Design Report Addendum
Response to RFIs

Mixed-Use Development with Infill Affordable Housing
13–17 Oxford Street and 2 Verona Street, Paddington NSW 2021

Date	Purpose
SSD Reference:	SSD-87245208
DPHI Reference:	RFI-120198738 (3 May 2026) and Addendum (7 May 2026)
CoS Reference:	R/2025/23/A (5 May 2026)
Prepared by:	Tonkin Zulaikha Greer (TZG) Architects
On behalf of:	WT Malouf, care of 17 Oxford St Pty Ltd

GFA Diagrams

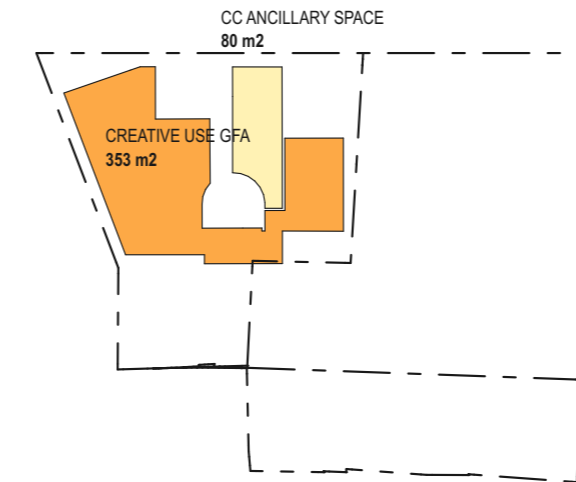
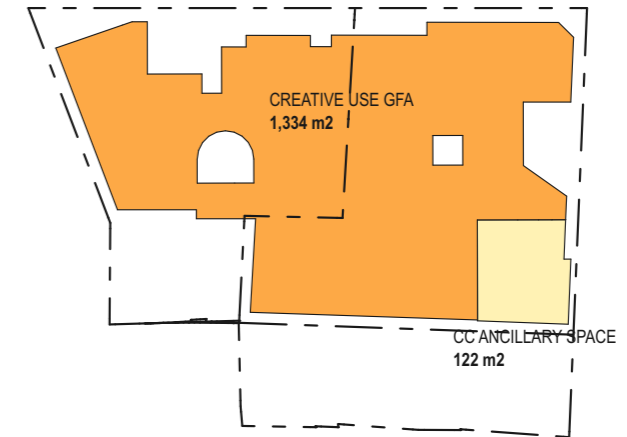
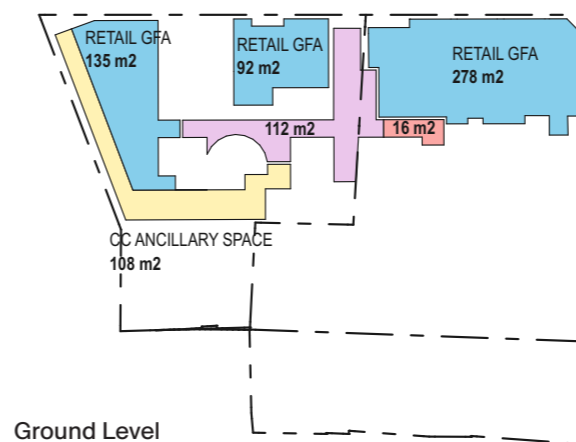
RFI 1 – Calculation of Cultural and Creative GFA	
Agency	NSW DPHI
RFI No.	1
RFI Comment	
<p>Existing GFA plans limit the calculation of cultural and creative floorspace to the auditoriums of the previous cinema, excluding circulation spaces, box office and cinema lobby. Proposed GFA plans include the cinema box office and lobby, circulation and bar areas as part of the cultural and creative GFA calculations. To confirm whether the proposed development would satisfy the requirements of cl. 6.60D(4)(c) of the Sydney Local Environmental Plan 2012 (SLEP) and in order to trigger alternative maximum FSR and building height controls, a consistent approach must be taken when calculating existing and proposed cultural and creative floorspace.</p> <p>a) Demonstrate a consistent approach for the calculation of cultural and creative GFA.</p> <p>b) Should the provided amount of proposed cultural and creative GFA not trigger alternative FSR and building height controls under cl. 6.60D, clarify the pathway sought for the proposed uplift beyond the maximum controls set out under cl. 4.4 and 4.5.</p>

Design Response	
<p>(a) Cultural and Creative GFA Calculation</p> <p>GFA has been recalculated based on the methodology approved in the previously approved DA. DA/D/2022/1169 (previous commercial office approval) applied the following calculation methodology, which has been adopted in this instance: only areas directly relating to the provision of cultural and creative space - such as the cinema auditoria themselves - are counted toward the cultural and creative GFA total. Ancillary spaces associated with the cultural and creative use, such as bathrooms and the ground floor lobby, are excluded from the calculation.</p> <p>Updated GFA Diagrams and General Arrangement plans are provided with this submission, with totals revised to reflect this methodology. As ancillary spaces were previously being included in the cultural and creative GFA total, the application of the consistent methodology resulted in a decrease in the calculated cultural and creative area. To ensure the development meets the required quantum of cultural and creative floor space necessary to access the alternative FSR and height controls under cl. 6.60D of the Sydney LEP 2012, additional cultural and creative floor space has been incorporated within the basement level of the building, through the introduction of a fourth</p>

basement level. Existing cultural and creative area, as per the previously approved DA, is 624sqm. 10% of the total GFA figure is 1,050sqm, requiring a minimum cultural and creative area of 1,674sqm. The proposed development provides 1,687sqm of creative use GFA, satisfying the required threshold.

The required amount of cultural and creative floorspace is provided in the amended scheme and the alternative FSR and building height controls are therefore triggered.

Level 1 General Arrangement Plan

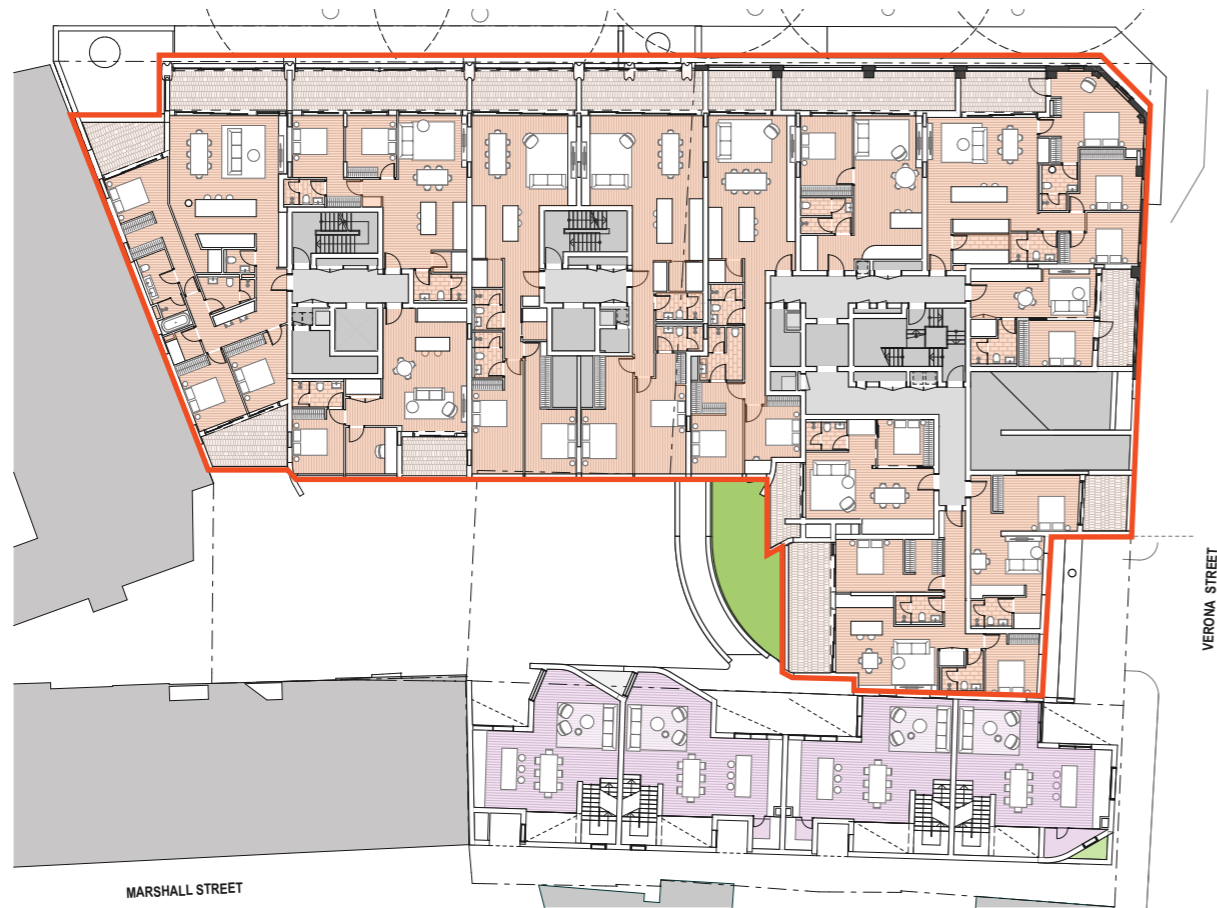
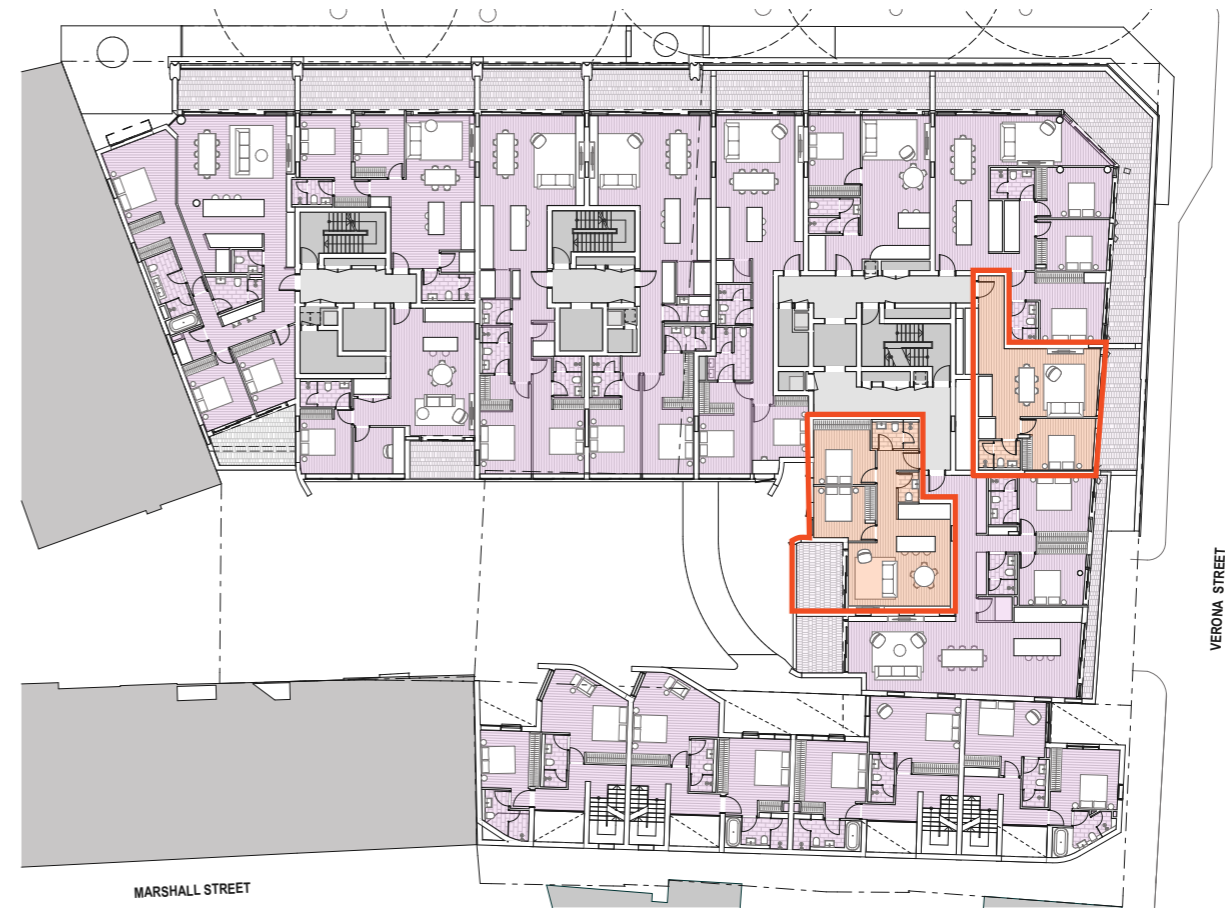
RFI 2 – Apartment Amenity: Affordable Housing	
Agency	NSW DPHI
RFI No.	2
RFI Comment	
<p>The Department remains concerned that the amenity of affordable housing is disproportionate to market units. Affordable units are generally subject to lower cross - ventilation (approximately 42% cross ventilated) and many have constrained solar access to living room windows via wintergardens, while also being more noise affected. You must further explore and demonstrate opportunities to ensure equitable amenity to residents, including options to reallocate the affordable housing units.</p>	
Design Response	
<p><i>Please also refer to Section 3.2 Response to City of Sydney Letter</i></p> <p>A review of the Level 1 affordable housing floor plate has been undertaken, resulting in a series of design amendments that substantially improve the amenity of the affordable apartments and bring the Level 1 floor plate into closer alignment with the build-to-sell product on the levels above.</p> <p>Statutory Context There is no statutory requirement that the amenity of affordable housing within a mixed development be equivalent to that of market apartments. Notwithstanding this, the amended design delivers a standard of amenity that is generous in absolute terms. The affordable apartments feature floor-to-ceiling glazing, oversized private open spaces in many instances, apartment sizes that meet or exceed the market product on comparable levels, additional bathrooms in two-bedroom and larger apartments, and walk-in pantries or laundries in a number of dwellings. The affordable offering spans studios, one-bedroom, two-bedroom and three-bedroom apartments, ensuring a diverse range of household types is accommodated. Two adaptable dwellings are retained within the affordable housing component, supporting accessibility and long-term housing flexibility.</p> <p>Changes to Level 1 The Level 1 floor plate has been redesigned to replicate the Level 2 floor plate as closely as possible, reflecting an equivalent standard of amenity to the build-to-sell product immediately above. Courtyard-facing balconies to dual-aspect apartments have been absorbed into the apartment interiors, increasing effective internal floor area. Apartments 1.01 and 1.02 have been consolidated into a single larger dual-aspect, naturally cross-ventilated apartment (now numbered 1.01), replicating the floor plan of the market apartments on the levels above. As a result of these amendments, the cross-ventilation and solar access performance of the Level 1 floor plate is only marginally different from Level 2.</p> <p>Where possible, the same planning and amenity has been provided, resulting in the affordable housing product being closely comparable to the build-to-sell product. Apartments 1.01 to 1.08 are identical in planning and performance to those on the levels above. Apartments 1.09 and 1.10 differ from the level above due to the location of the OSD tank on Level 1. The configuration of apartments</p>

The affordable apartments are located on Levels 1 and 2. Most apartments have oversized balconies as well as walk-in laundries and storage surplus to ADG requirements.

Wintergardens are retained for apartments 1.01, 1.02, 1.04 and 1.05, which front Oxford Street and are noise affected. Wintergardens are also retained for apartments located behind the existing Verona Street facade, where the heritage fabric is to be preserved, and for the studio apartment above the loading dock, where the wintergarden provides additional separation from the loading dock below. This approach is consistent with the requirements of DPHI RFI Item 3 and the City of Sydney's comment at RFI Item 3 of Annexure A. Courtyard-facing apartments that are not noise affected are provided with open balconies consistent with the market apartments on the levels above.

Design amendments have been made to the facade of noise-affected units to ensure solar penetration on the winter solstice is achieved within the living room. Apartments 1.01, 1.02, 1.04 and 1.05 retain wintergardens due to noise affectation from Oxford Street; solar access to living room windows for these apartments is assessed through the wintergarden glazing. The solar access assessment has been reviewed accordingly and updated diagrams are included in the amended drawing package. Level 1 apartments located behind the existing Verona Street facade are retained in their current configuration to preserve the existing facade fabric, and the solar access outcomes for these apartments are addressed in the context of the heritage constraint. Refer also to the response to City of Sydney RFI Item 4.2 within this document.

Updated cross-ventilation diagrams have been prepared reflecting the amended floor plate, including the consolidation of apartments 1.01 and 1.02 into a single larger dual-aspect dwelling. The diagrams demonstrate compliance with the ADG definition of natural cross-ventilation — that the primary living space and n-1 bedrooms are on a ventilation path. The ADG does not require affordable dwellings to be separately assessed to independently achieve cross-ventilation compliance. Objective 4B-3 requires at least 60% of dwellings across the whole development to be naturally cross-ventilated. The development achieves 64% (41 of 64 dwellings), meeting this threshold. The design amendments to the Level 1 floor plate improve the affordable housing cross-ventilation outcome and reduce the disparity with the market apartments.

Level 1 General Arrangement Plan

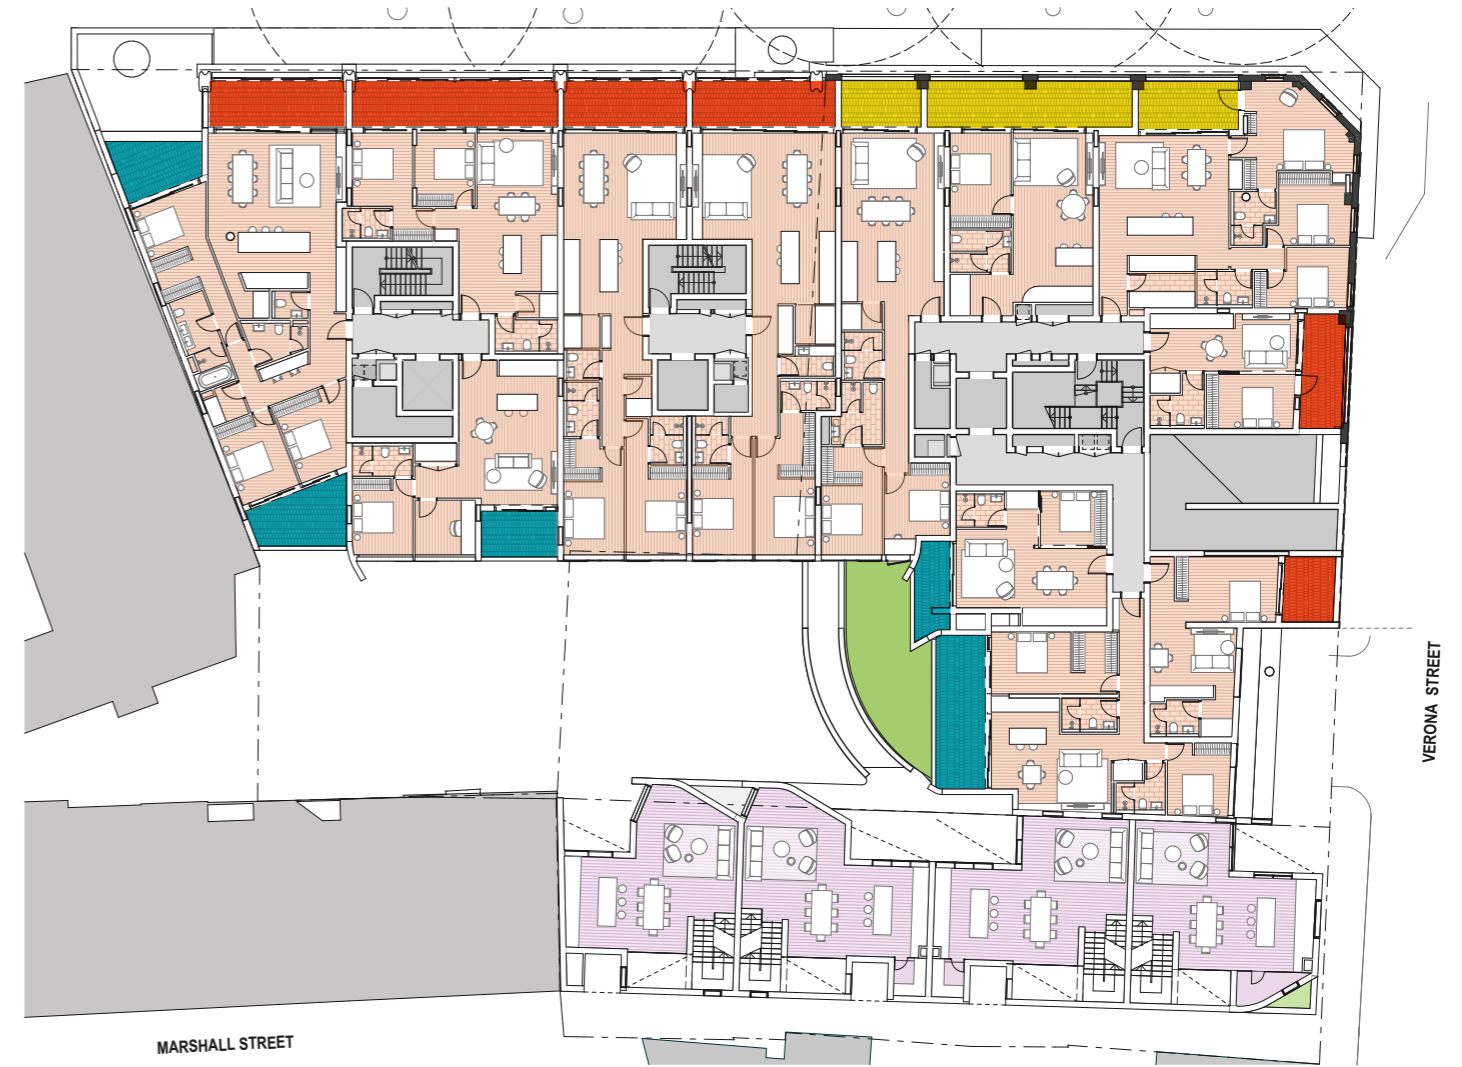
RFI 3 – Wintergardens: Noise-Affected Apartments Only	
Agency	NSW DPHI
RFI No.	3
RFI Comment	Amend the proposal to ensure that wintergardens are only provided where required for noise affected apartments.
Design Response	<p>Wintergardens in the proposed scheme have been redesigned and reallocated in response to feedback from DPHI and the City of Sydney.</p> <p>Wintergardens are retained where required by noise affectation. Apartments 1.01, 1.02, 1.04 and 1.05 front Oxford Street and are noise affected; wintergardens are therefore retained for these apartments. Wintergardens are also retained where private open space sits within the existing Verona Street building facade, in order to preserve the existing building fabric and character, this applies to apartments 1.06, 1.07 and 1.08. Wintergardens are also provided to apartments 1.09 and 1.10 due to their adjacency to Verona Street and the building's loading dock. Courtyard-facing apartments 1.03, 1.11 and 1.12 are provided with open balconies, as they are not noise affected.</p>

Detail: Level 01 Floor Plan - updated

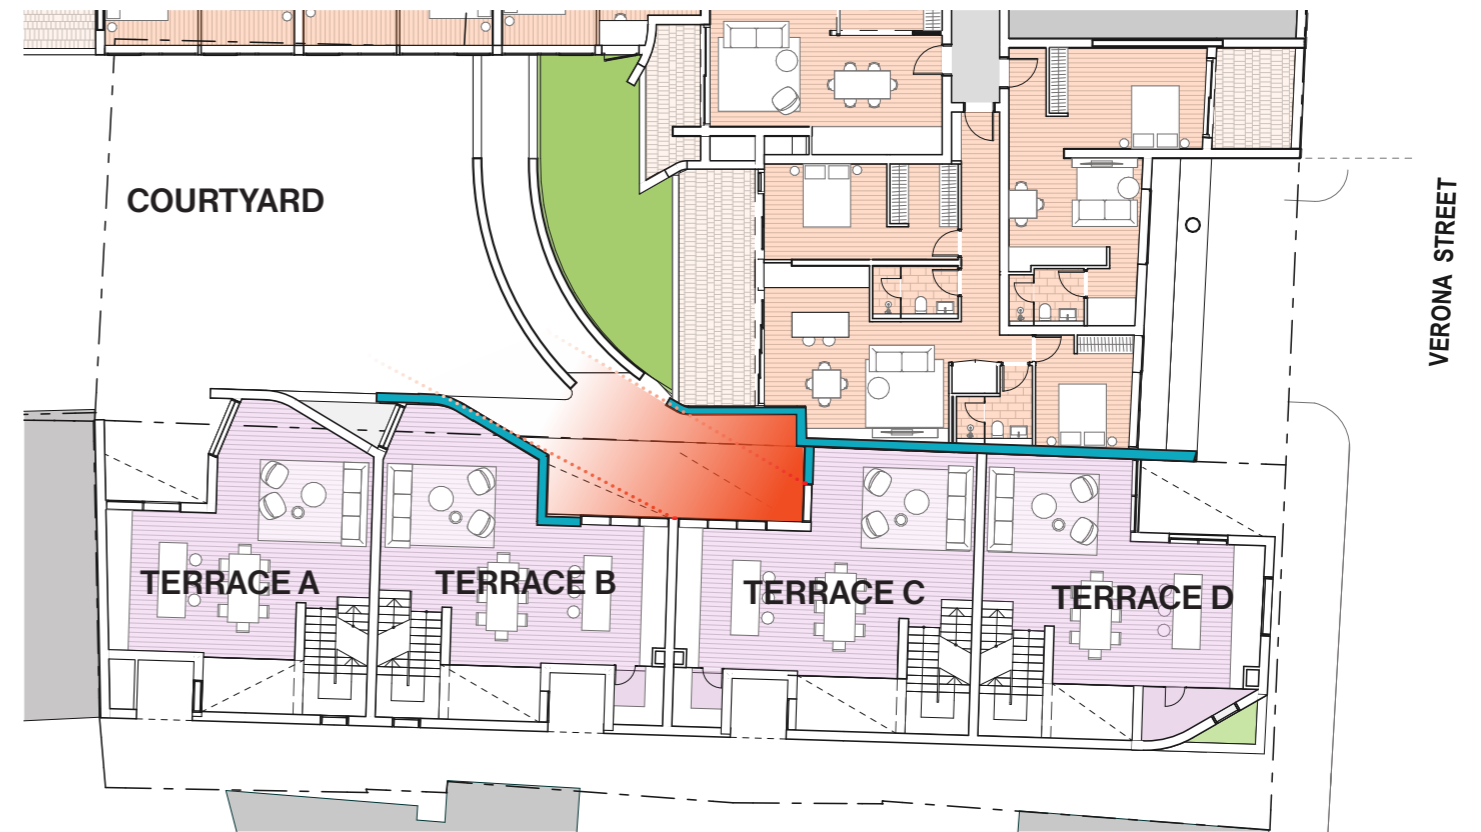
RFI 4 – Outlook from Terrace C	
Agency	NSW DPHI
RFI No.	4
RFI Comment	
Outlook from Terrace C remains constrained. You must explore opportunities to improve outlook, including but not limited to a reconfiguration of the adjacent balconies to apartments 2.10–4.10 to align with the upper levels of the building (Floors 5 and 6).	
Design Response	
Further design amendments have been made to improve outlook from Terrace C. The balcony and party wall of apartments 1.11, 2.10, 3.10 and 4.10 have been set back away from Terrace C, increasing the separation between Terrace C and the adjacent apartments across all levels. This amendment widens the view opening to the courtyard from within Terrace C and its private 27sqm rooftop outdoor area, improving both the sense of enclosure and the quality of outlook available to residents of Terrace C. The distance between the terrace C outdoor area and the party wall of unit 3.10 is approximately 3.5m

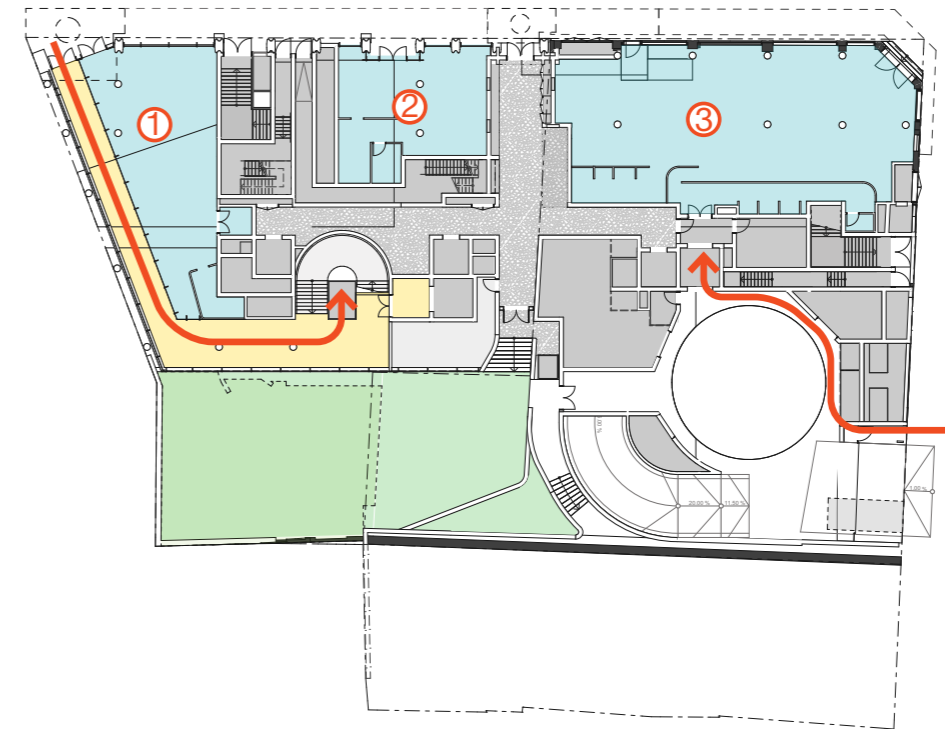
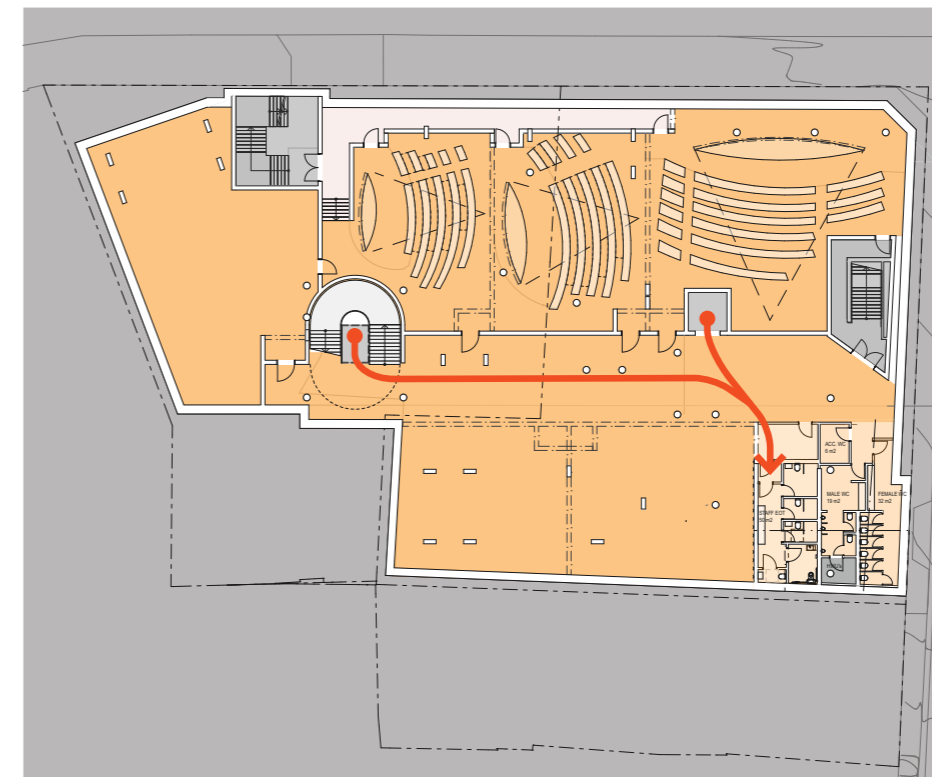
RFI 7 – Retail Staff Access to Basement 3 EOT Facilities	
Agency	NSW DPHI
RFI No.	7
RFI Comment	
Confirm how retail staff access to Basement 3 EOT facilities will be managed and assured, noting that users would need to traverse the cinema for access.	
Design Response	
<p>Access to the Basement 3 end-of-trip facilities is via either the service lift adjacent to the loading dock, or via the cultural and creative lift. Staff take either of these lifts to Basement 3 to access the end-of-trip facilities. Bicycle storage is located on Basement Level 2. Security access will be provided to staff to access the bicycle storage within the basement.</p> <p>There is no need for retail staff to traverse the cinema. The space between the service lift and the EOT facilities is an open-access area with no impediments. Within the end-of-trip, an accessible toilet and shower is provided, an ambulant unisex toilet, and three unisex bathrooms each with basin, shower and toilet in one compartment. The EOT facilities are provided in addition to male and female WCs located adjacent.</p>

1. Retail tenancies 1, 2 and 3 can access the end of trip facilities via either the Cultural Creative lift or the service lift

2. End of trip facilities located on Basement Level 3
